<h1 style="margin: 0;">TECHNICAL BULLETIN</h1> <h2 style="margin: 0;">No. 0110</h2>	<h1 style="margin: 0;">Operator's Panel Plate</h1>
---	--

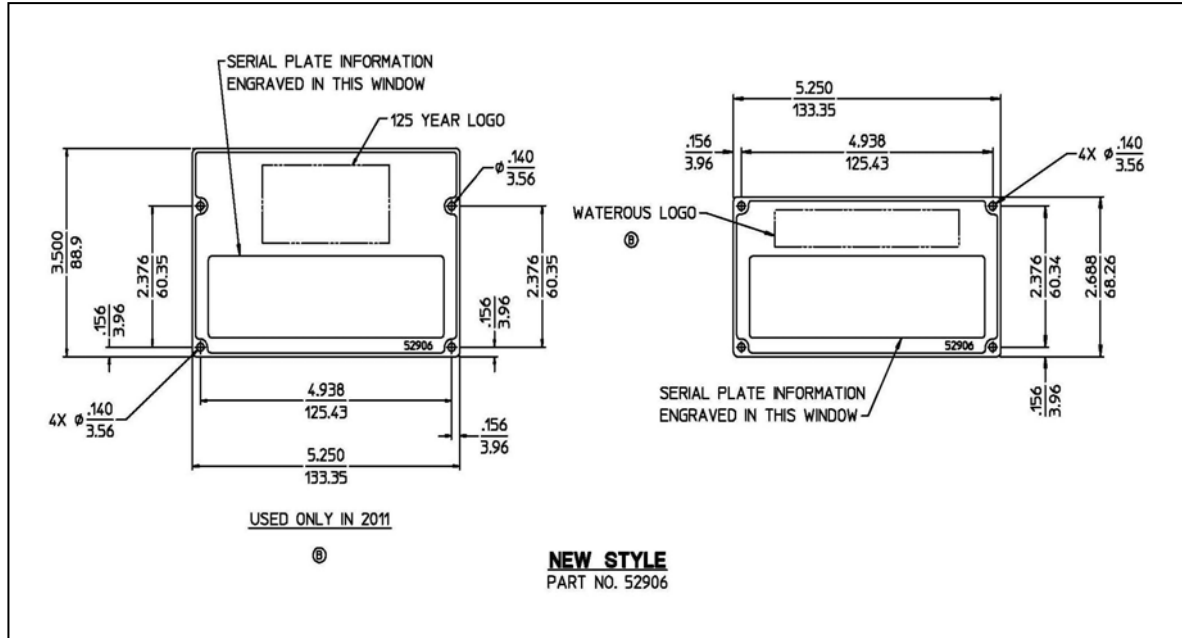
Effective on orders scheduled to ship January 3, 2011, Series Number Panel Plate will increase in overall height to accommodate the new Waterous anniversary logo. Note that this panel plate will be used from January 1, 2011 to December 31, 2011 only.

- Plate Dimensions:** The height of the panel plate has increased by .812 inches to accommodate the new Waterous 125<sup>th</sup> anniversary logo. All other dimensions of the panel plate remain the same including the attachment points (see figure below).
